BROWNS FERRY NUCLEAR PLANT (BFN) – UNITS 1, 2, AND 3 – TECHNICAL SPECIFICATIONS (TS) CHANGES TS-418 AND TS-431 – EXTENDED POWER UPRATE (EPU) – RESPONSE TO ROUND 23 REQUEST FOR ADDITIONAL INFORMATION (RAI) REGARDING STEAM DRYER SIGNAL PROCESSING (TAC NOS. MD5262, MD5263, AND MD5264)

**TENNESSEE VALLEY AUTHORITY
BROWNS FERRY NUCLEAR PLANT (BFN)
UNITS 1, 2, AND 3**

**TECHNICAL SPECIFICATIONS (TS) CHANGES TS-431 AND TS-418
EXTENDED POWER UPRATE (EPU)**

**RESPONSE TO ROUND 23 REQUEST FOR ADDITIONAL INFORMATION (RAI)
REGARDING STEAM DRYER SIGNAL PROCESSING**

Figure EMCB.203-1.7a: Phase of measured data for BFN1 main steam line A, for LF conditions (black, top) and corresponding EIC (red, bottom).

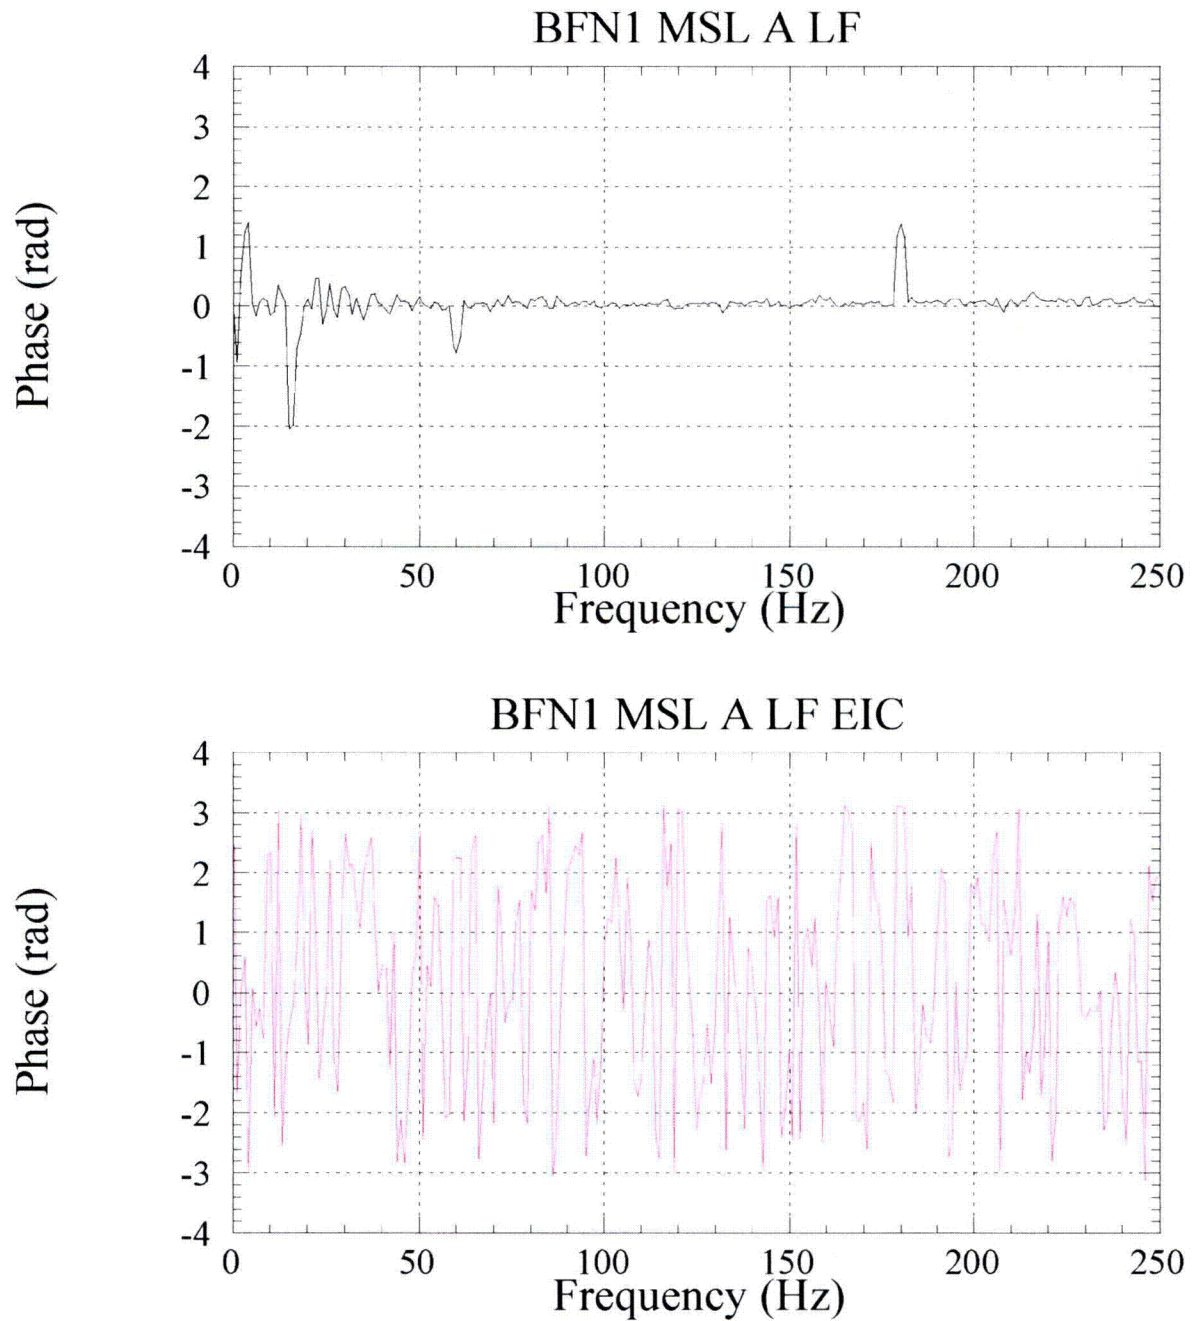
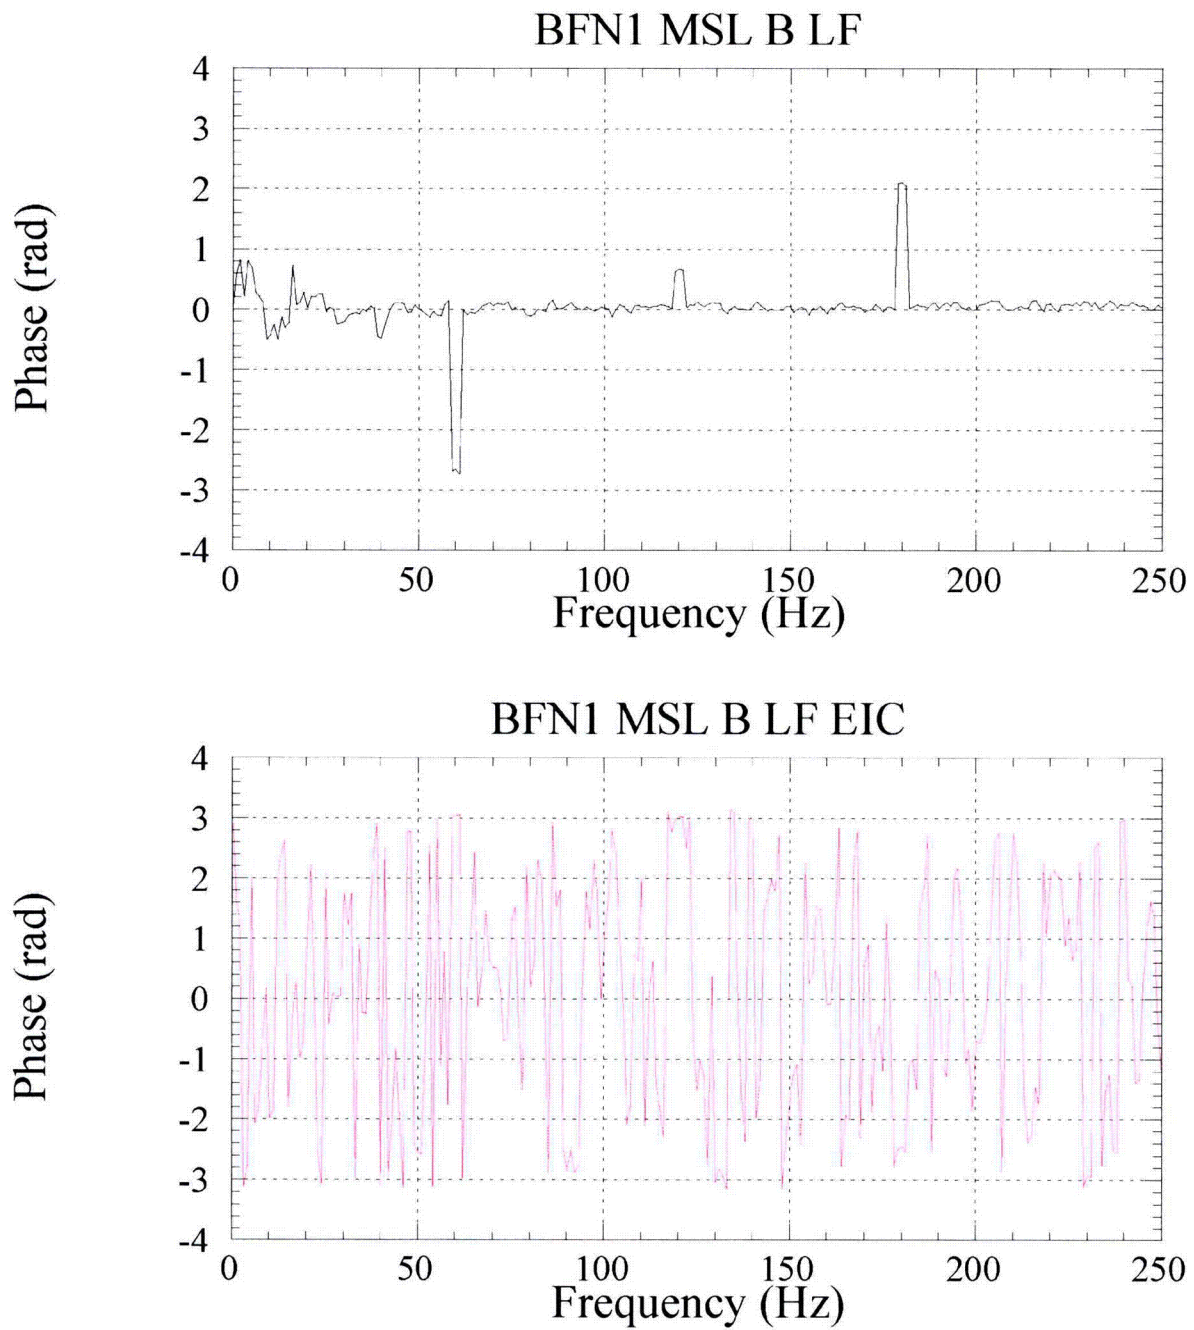
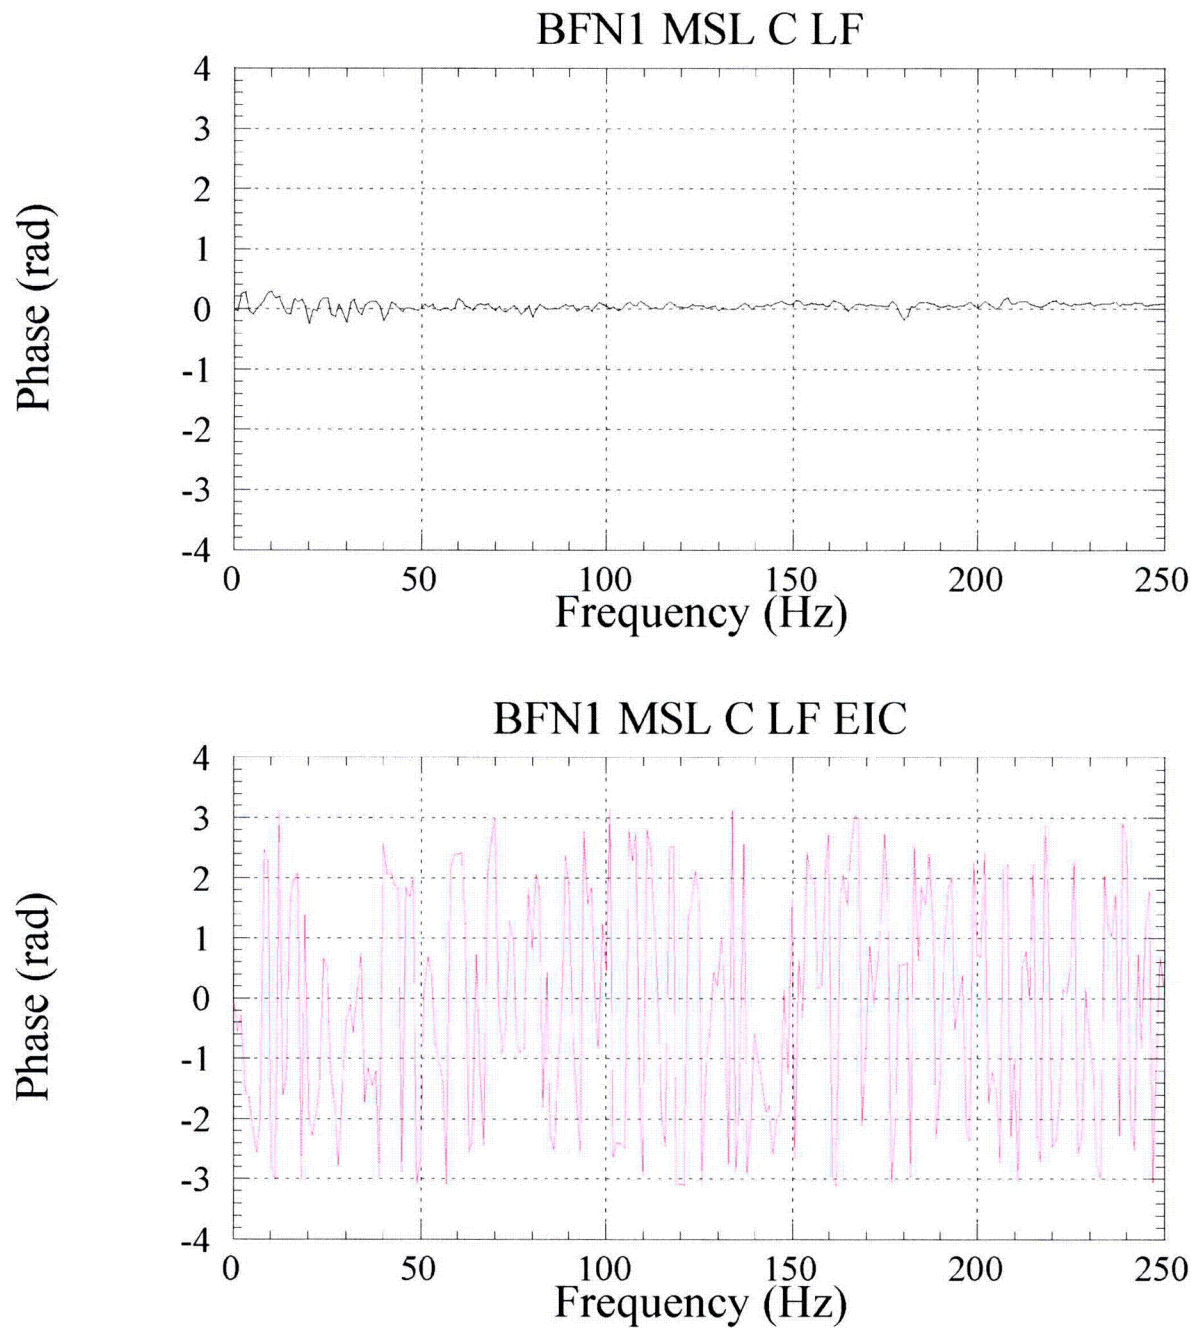
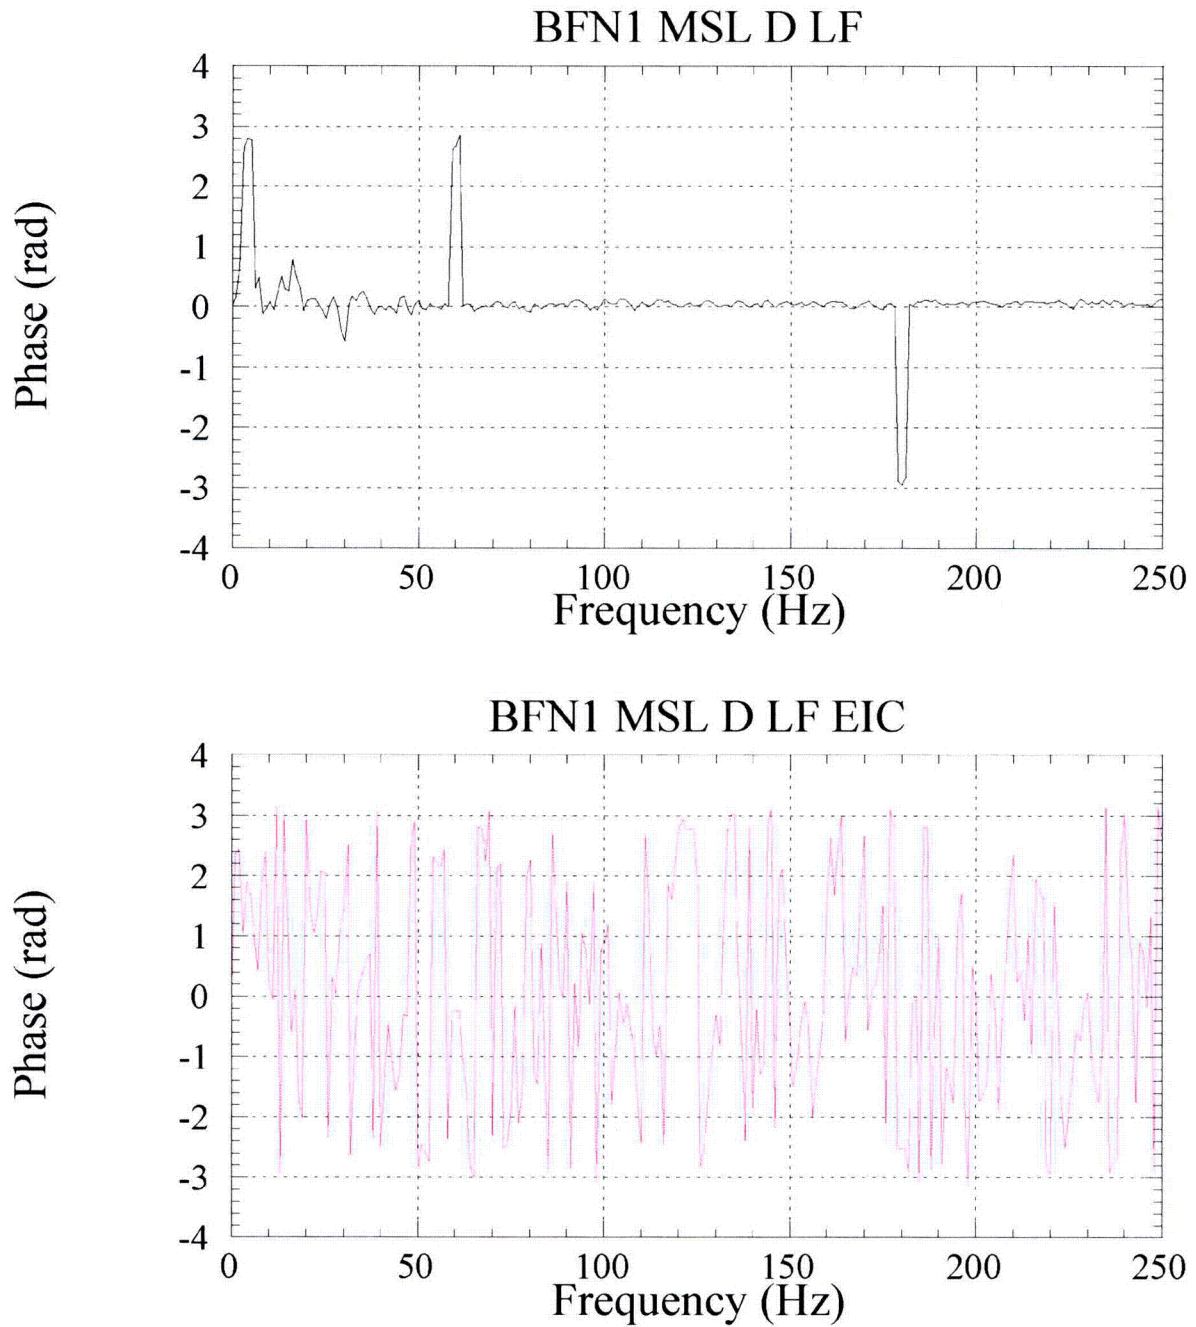
In response to EMCB.200/157., TVA presents detailed discussion of signal conditioning in six steps. Provide plots of strain gage signals (autospectra, cross spectra, coherence, and phase) and computed [[]] throughout the procedure described in their RAI response (prior to step 1, after step 1, after step 2, after step 4 and after step 6), for current license thermal power (CLTP) and Low Flow (LF) signals, for Units 1 and 2.

The requested plots for Unit 1 are listed and provided below. The requested plots for Unit 2 are scheduled to be provided by January 23, 2009.
